star bulletin

Date: November 14, 2013
Order No.: P-B-00.20/103
Group: 00

SUBJECT: MY-All, Model 117.352

Rear Axle Differential Oil Change

Figure 1. Service Item

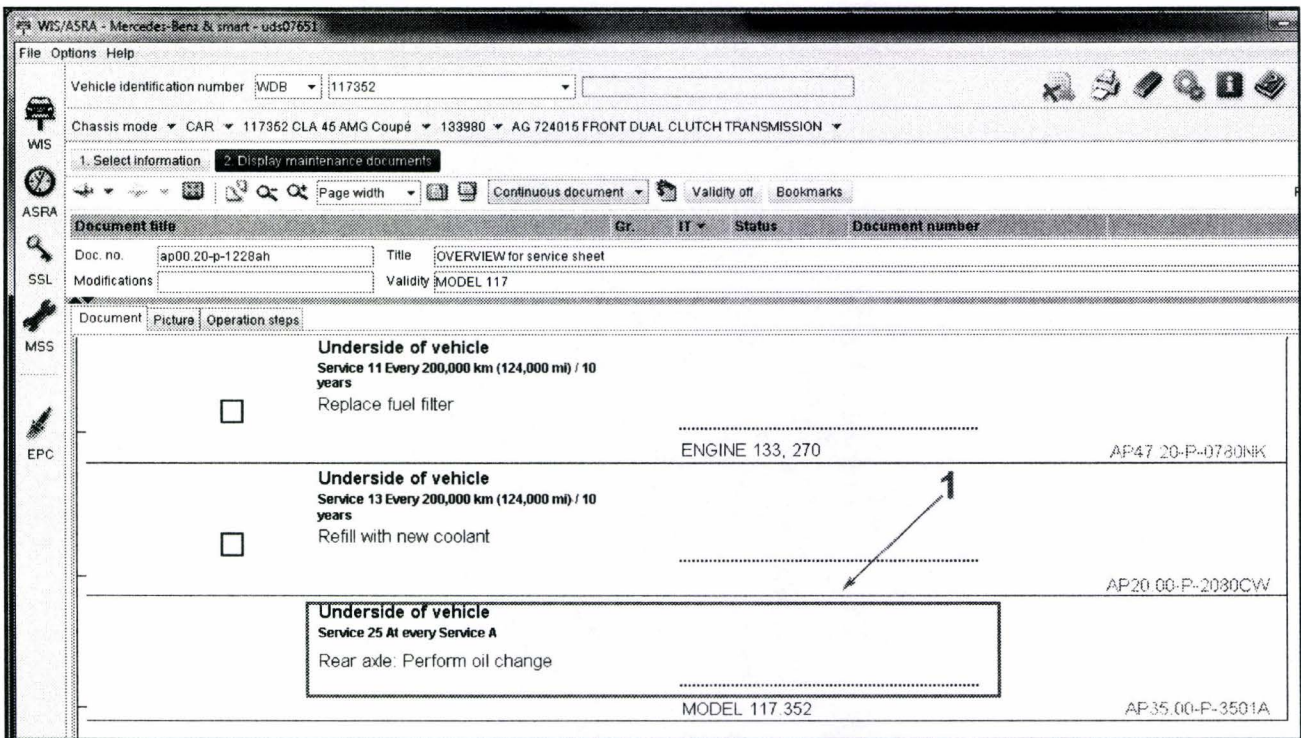
Ensure that maintenance is conducted according to manufacturer guidelines for the above-mentioned AMG vehicle. Service item (Figure 1) (1) "Rear axle: Change oil" must be observed for every Service A.

This additional operation "Rear axle: Change oil" is only partially controlled through ASSYST or the workshop code and is therefore also not always displayed automatically in the vehicle-specific service sheets in the WIS/MSS.

NOTE: The drain screw no longer needs to be replaced. Remove sealing ring from drain and filling screw and replace with new sealing ring.
